COMAL COUNTY

Permit of Authorization to Construct an On-Site Sewage Facility Permit Valid For One Year From Date Issued

Permit Number: 118834
Issued This Date: 09/03/2025
This permit is hereby given to: Jeff Johnson, Patty Johnson Perez, Cynthia McCarley

5691 CIRCLE OAK DR
CITY OF BULVERDE, TX 78163

240 GPD
Spray Configuration
S-1 -180 Degree 27' Radius = 1,144.53
S-2 -180 Degree 22' Radius = 759.88
S-3 -180 Degree 20' Radius = 628.00
S-4 -180 Degree 30' Radius = 1,413.00

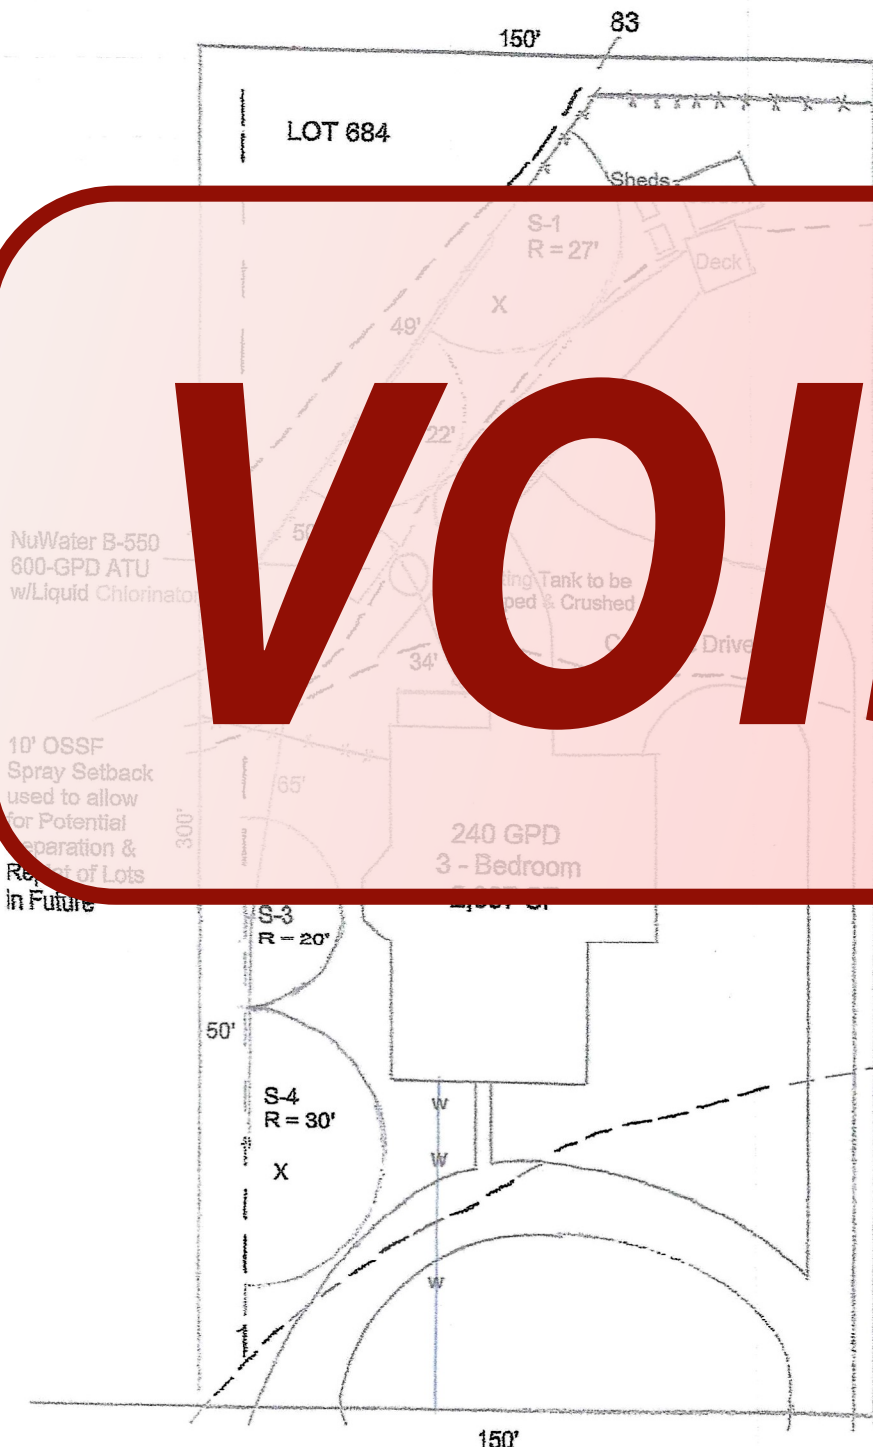
Thank you for your submission. We have reviewed the planning materials for the referenced permit application, and unfortunately, they are insufficient. To proceed with processing this permit, we require the following:

- ✓ 1. It appears that the two properties are not combined, and the generating unit and disposal are fit on Lot 684.
 - ✓ a. Please remove Lot 685 from all documents.
 - ✓ b. It is not a requirement but a recommendation that the Affidavit requiring maintenance be updated to reflect Lot 684 only, in the case the owner wants to sell the other portion of the property without involving Lot 684.
2. Revise accordingly and resubmit.
